SUPPLEMENT

PAJERO '95

ELECTRICAL WIRING SUPPLEMENT

This publication is a supplement to the Electrical Wiring Manual Pub. No. PHJE9026 and contains only additions and changes to the original issue. It is recommended that all service mechanics engaged in the servicing of the vehicle refer to the following publications as well as this manual.

L.H. drive vehicles with 6G72 engine

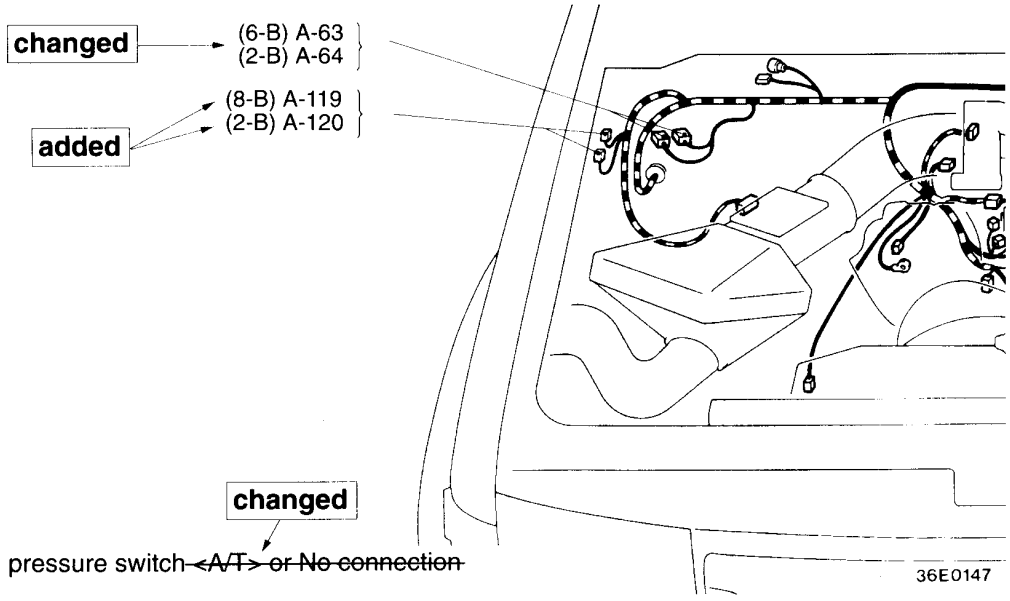
- The ABS relay box (A-119, 120) has been added.
- Terminal numbers of the hydraulic unit (A-63) have been changed from ten to six.
- M/T vehicles have also had the power steering oil pressure switch (A-117).

A-117 Power steering oil pressure switch ~~<A/T> or No connection~~
A-118 Air flow sensor
A-119, A-120 ABS relay box ← added

R.H. drive vehicles with 6G72 engine

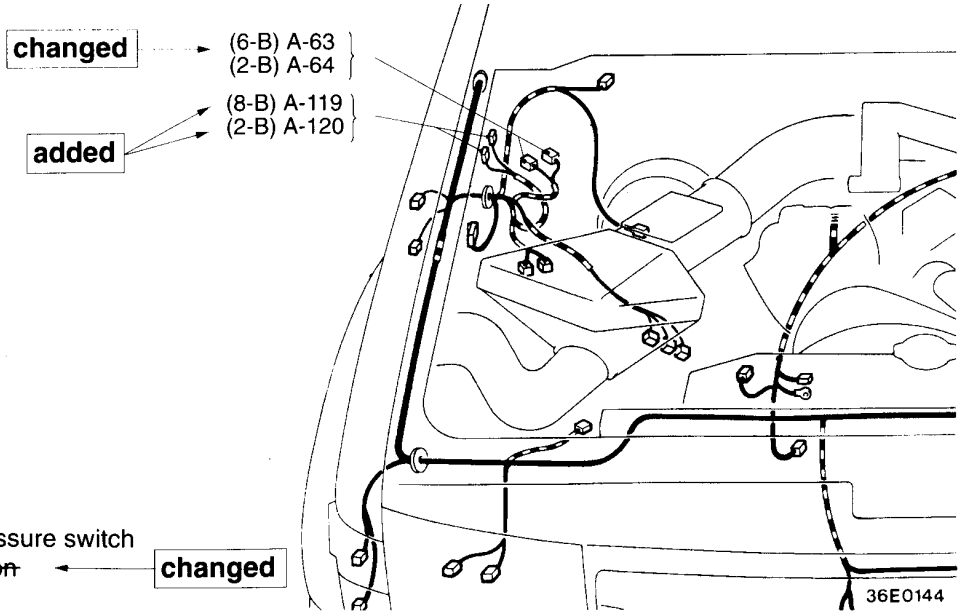
- The ABS relay box (A-119, 120) has been added.
- Terminal numbers of the hydraulic unit (A-63) have been changed from ten to six.
- M/T vehicles have also had the power steering oil pressure switch (A-117).

A-117 Power steering oil pressure switch ~~<A/T> or No connection~~ ← changed
A-118 Air flow sensor
A-119, A-120 ABS relay box ← added

L.H. drive vehicles with 6G74 engine

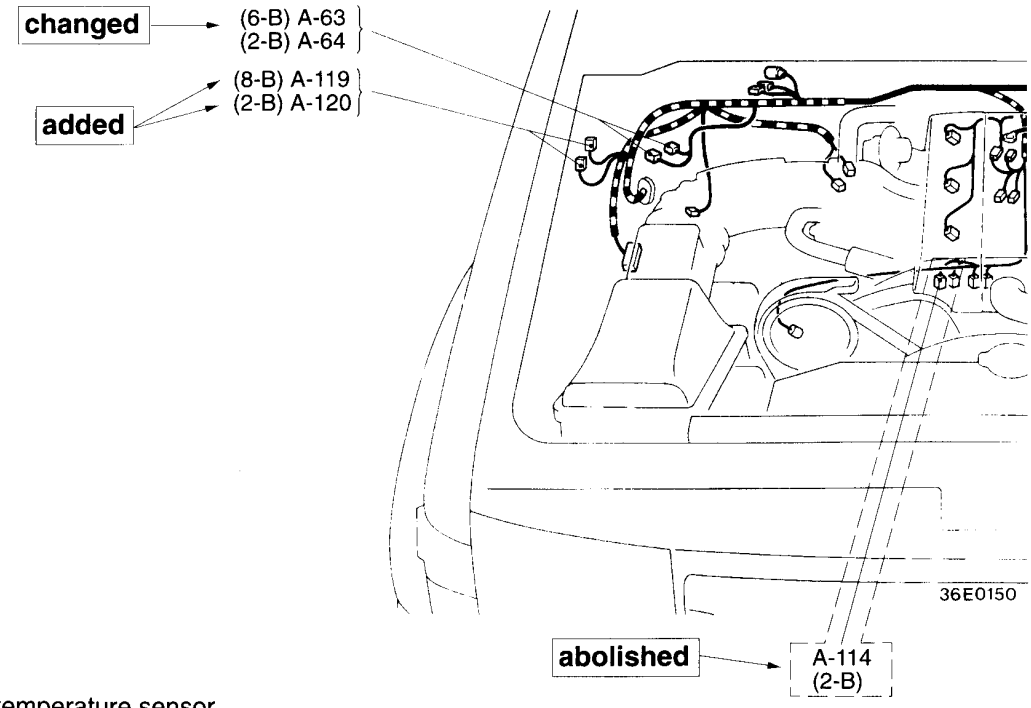
- The ABS relay box (A-119, 120) has been added.
- Terminal numbers of the hydraulic unit (A-63) have been changed from ten to six.
- M/T vehicles have also had the power steering oil pressure switch (A-117).
- The engine coolant temperature switch (for A/C compressor control) (A-114) has been abolished.

A-113 Engine coolant temperature sensor
A-114 ~~Engine coolant temperature switch (for A/C compressor control)~~ – ← abolished
A-115 Camshaft position sensor
A-116 –
A-117 Power steering oil pressure switch ~~<A/T> or No connection~~ ← changed
A-118 Air flow sensor
A-119, A-120 ABS relay box ← added

R.H. drive vehicles with 6G74 engine

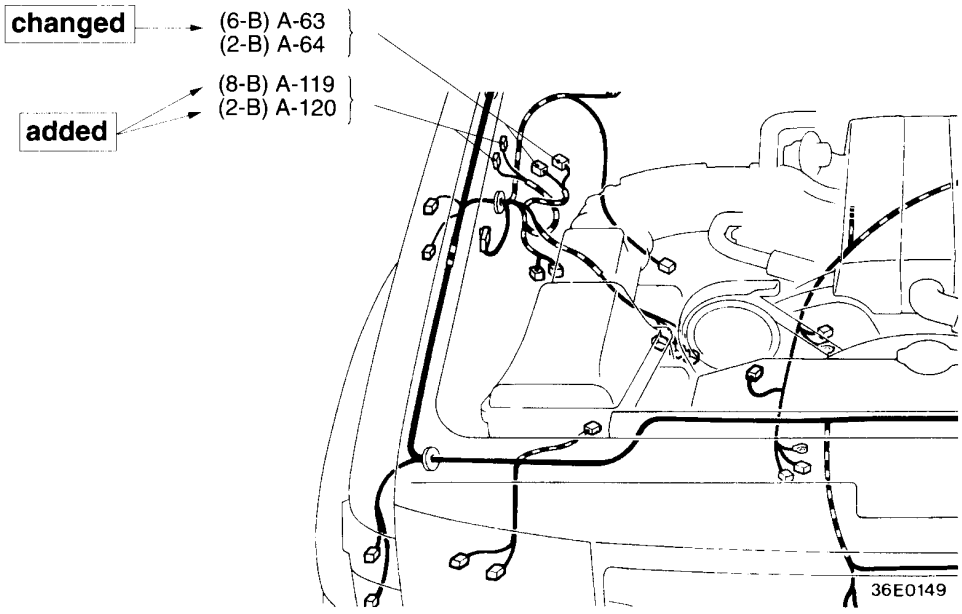
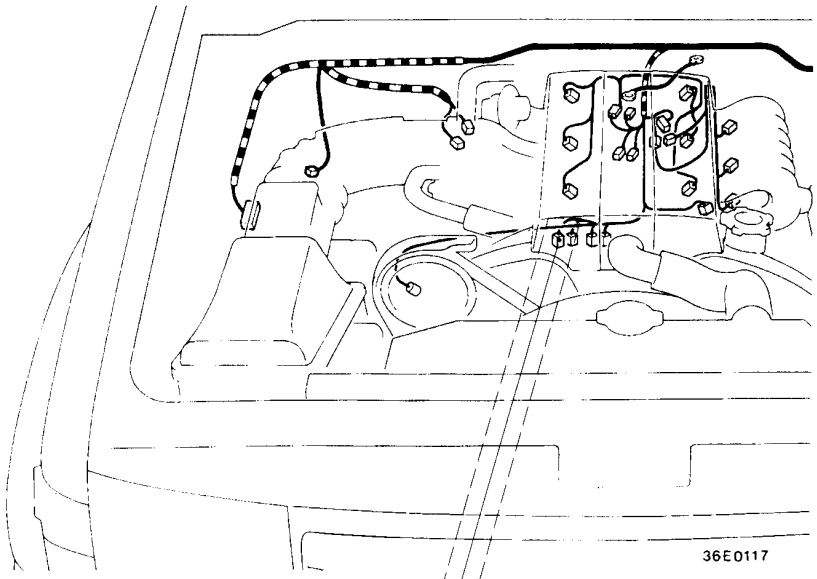
- The ABS relay box (A-119, 120) has been added.
- Terminal numbers of the hydraulic unit (A-63) have been changed from ten to six.
- M/T vehicles have also had the power steering oil pressure switch (A-117).
- The engine coolant temperature switch (for A/C compressor control) (A-114) has been abolished.

abolished ← A-114 (2-B)

A-113 Engine coolant temperature sensor
A-114 ~~Engine coolant temperature switch (for A/C compressor control)~~ – ← abolished
A-115 Camshaft position sensor
A-116 –
A-117 Power steering oil pressure switch ~~<A/T> or No connection~~ ← changed
A-118 Air flow sensor
A-119, A-120 ABS relay box ← added

R.H. drive vehicles with 4D56 engine

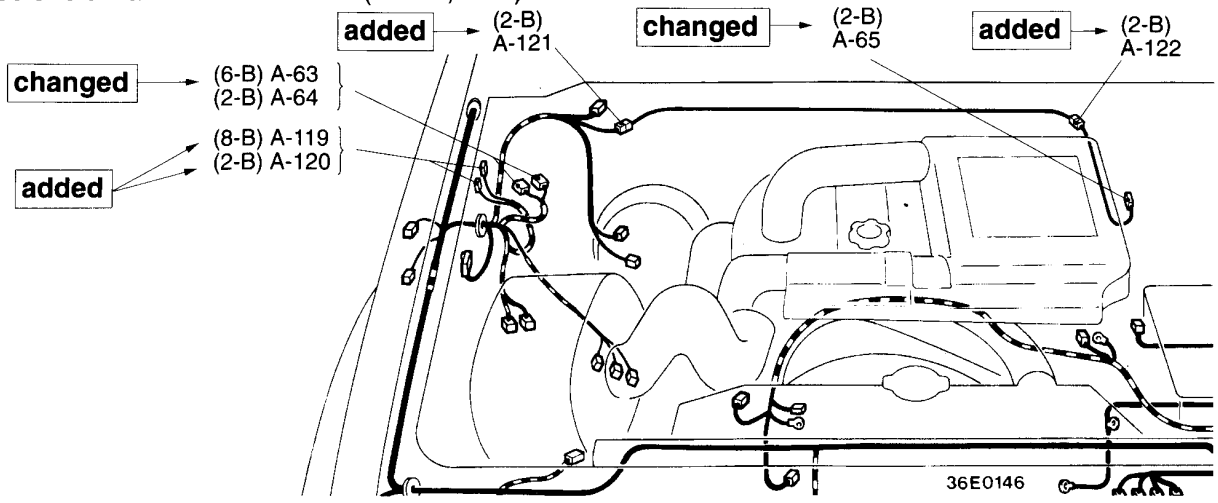
- The ABS relay box (A-119, 120) has been added.
- Terminal numbers of the hydraulic unit (A-63) have been changed from ten to six.
- The installation position of the idle-up solenoid valve <ABS> (A-65) has been changed.
- The solenoid valve sub harness (A-121, 122) has been added.

A-116 Engine coolant temperature switch (for condenser fan motor control)
A-117 –
A-118 –
A-119, A-120 ABS relay box ← added
A-121 Solenoid valve sub harness (A) and control wiring harness combination ← added
A-122 Solenoid valve sub harness (A) and solenoid valve sub harness (B) combination ← added

R.H. drive vehicles with 4M40 engine

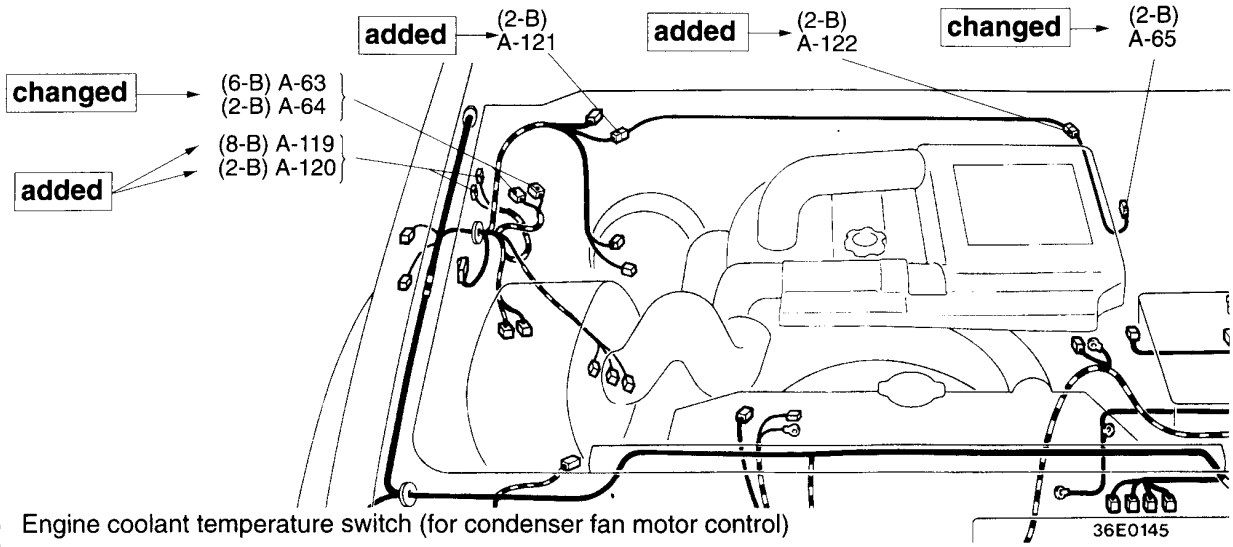
- The ABS relay box (A-119, 120) has been added.
- Terminal numbers of the hydraulic unit (A-63) have been changed from ten to six.
- The installation position of the idle-up solenoid valve <ABS> (A-65) has been changed.
- The solenoid valve sub harness (A-121, 122) has been added.

A-116 Engine coolant temperature switch (for condenser fan motor control)
A-117 –
A-118 –
A-119, A-120 ABS relay box ← added
A-121 Solenoid valve sub harness (A) and control wiring harness combination. ← added
A-122 Solenoid valve sub harness (A) and solenoid valve sub harness (B) combination ← added

2-door models <L.H. drive vehicles>

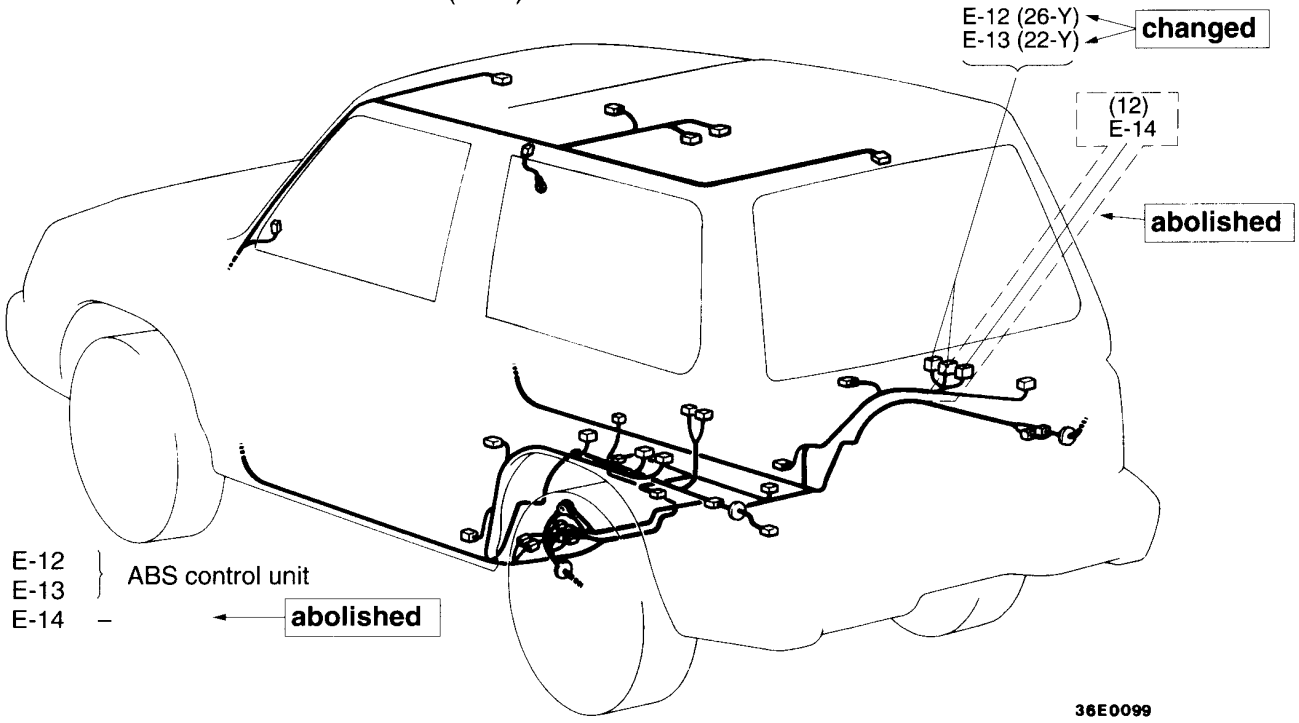
- Terminal numbers of the ABS control unit connector (E-12) have been changed from 18 to 26.
- Terminal numbers of the ABS control unit connector (E-13) have been changed from 12 to 22.
- The ABS control unit connector (E-14) has been abolished.

2-door models <R.H. drive vehicles>

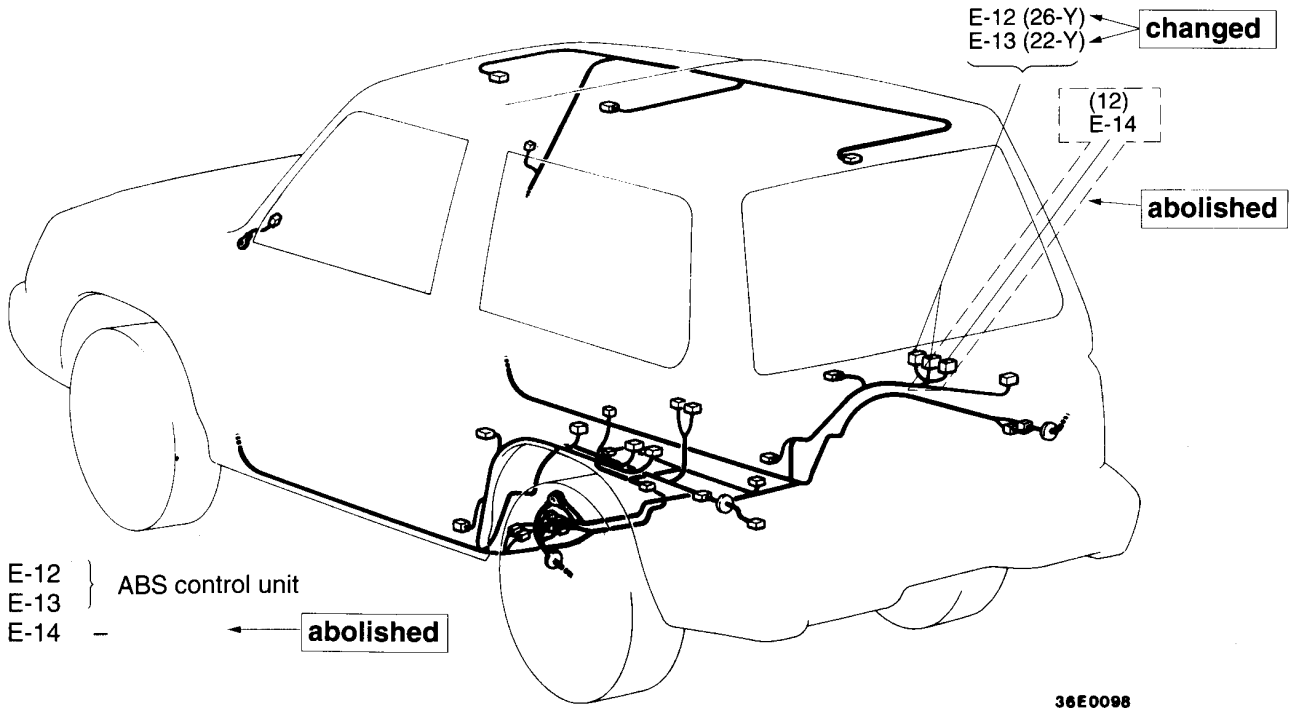
- Terminal numbers of the ABS control unit connector (E-12) have been changed from 18 to 26.
- Terminal numbers of the ABS control unit connector (E-13) have been changed from 12 to 22.
- The ABS control unit connector (E-14) has been abolished.

4-door models <L.H. drive vehicles>

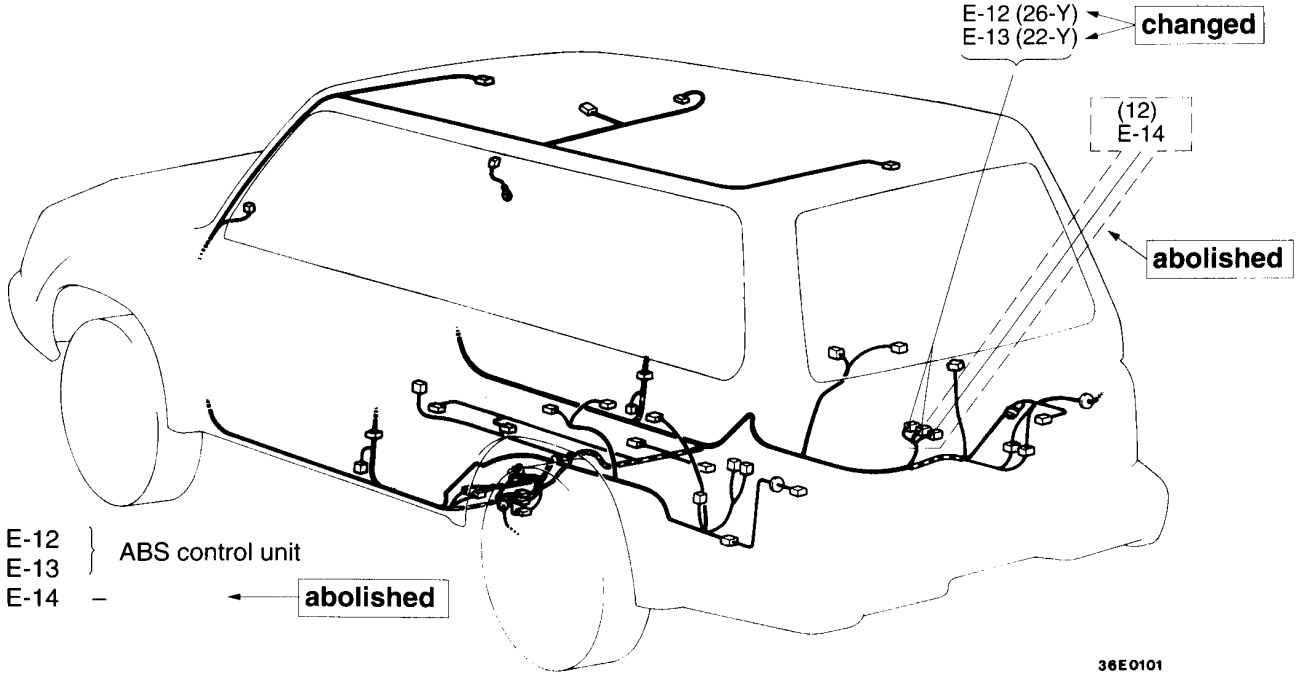
- Terminal numbers of the ABS control unit connector (E-12) have been changed from 18 to 26.
- Terminal numbers of the ABS control unit connector (E-13) have been changed from 12 to 22.
- The ABS control unit connector (E-14) has been abolished.

4-door models <R.H. drive vehicles>

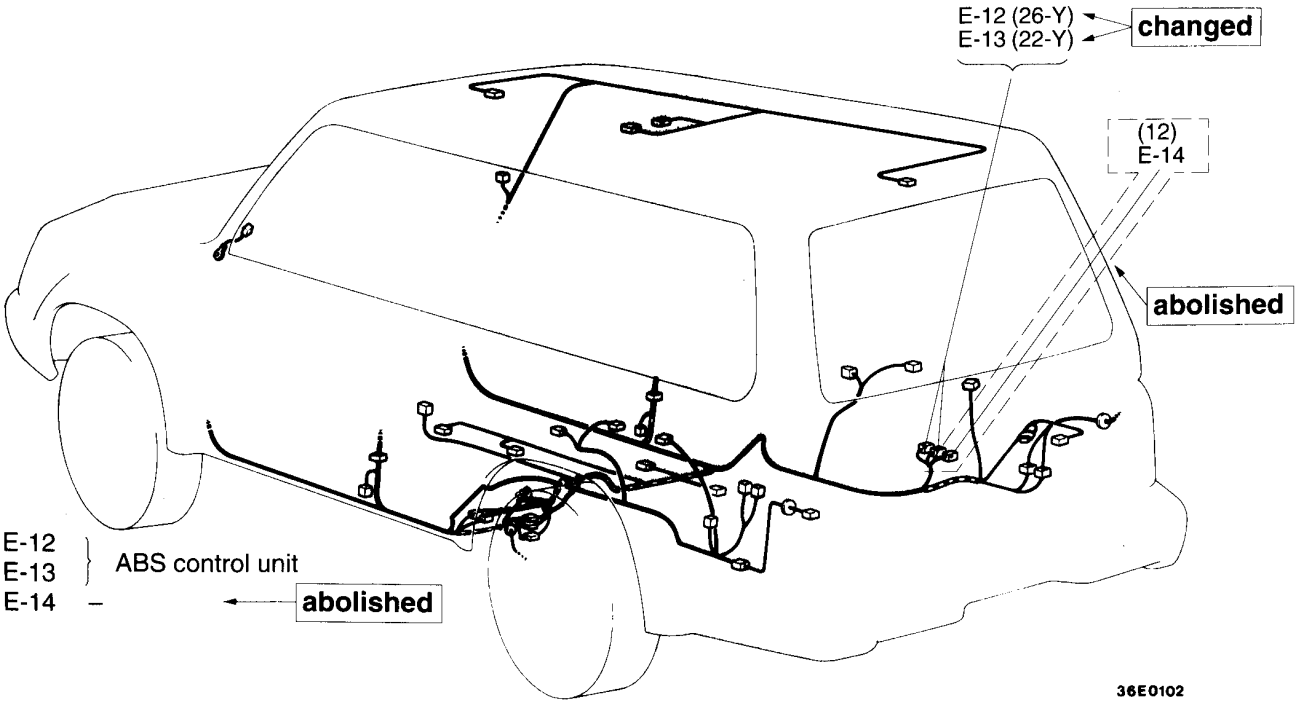
- Terminal numbers of the ABS control unit connector (E-12) have been changed from 18 to 26.
- Terminal numbers of the ABS control unit connector (E-13) have been changed from 12 to 22.
- The ABS control unit connector (E-14) has been abolished.

RELAY

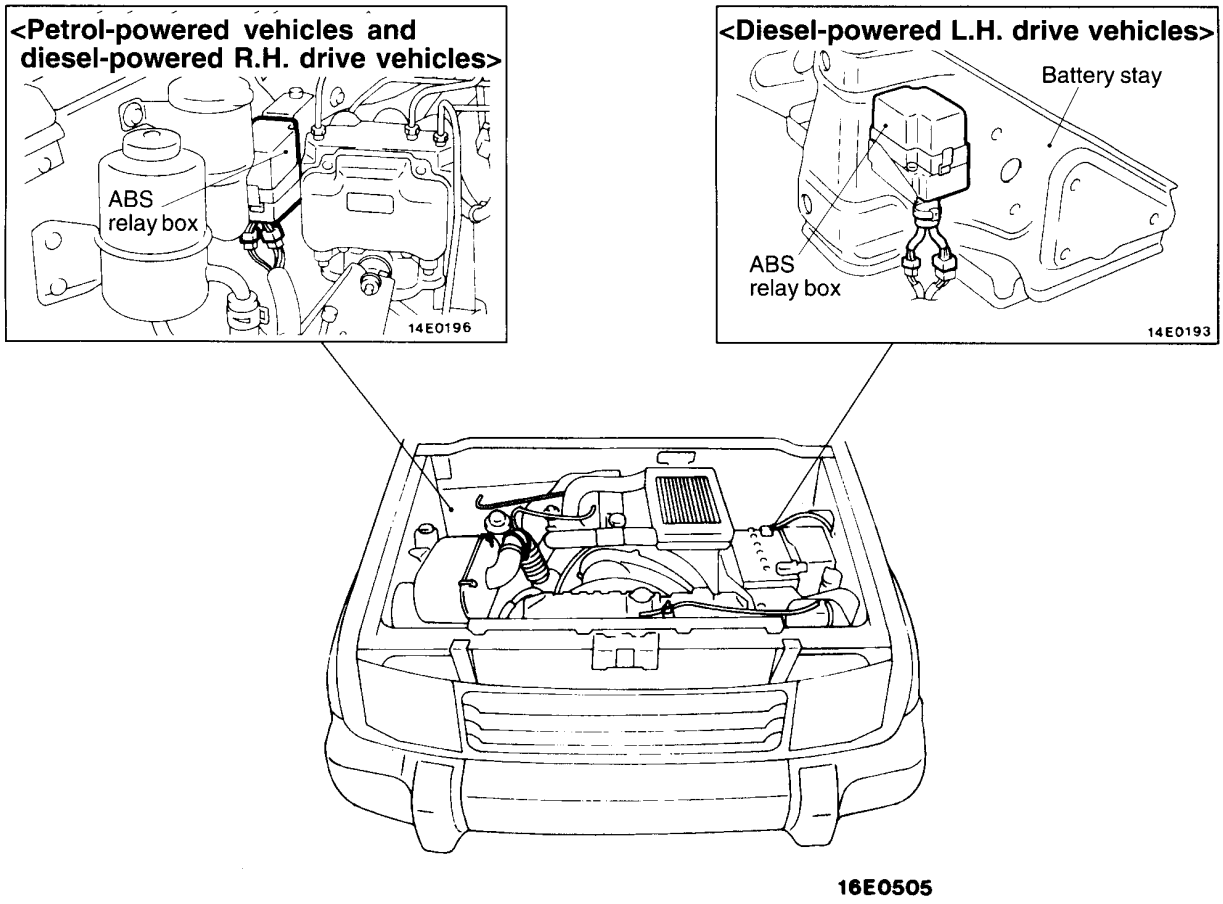
The ABS valve relay and motor relay have not been incorporated in the hydraulic unit any more. The ABS relay box, which contains these relays, has been added.

SOLENOID VALVE

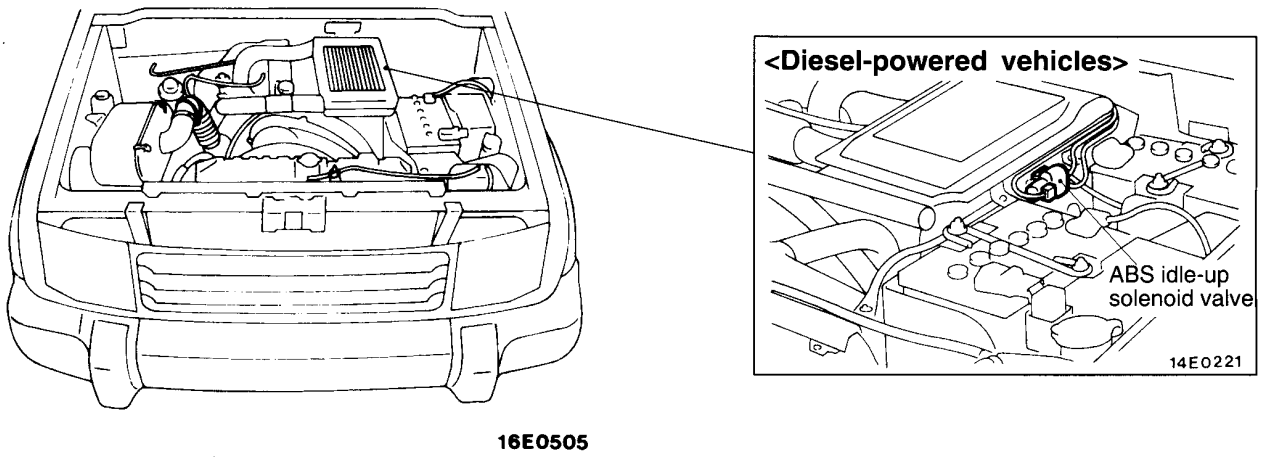
The installation position of the ABS idle-up solenoid valve has been changed.
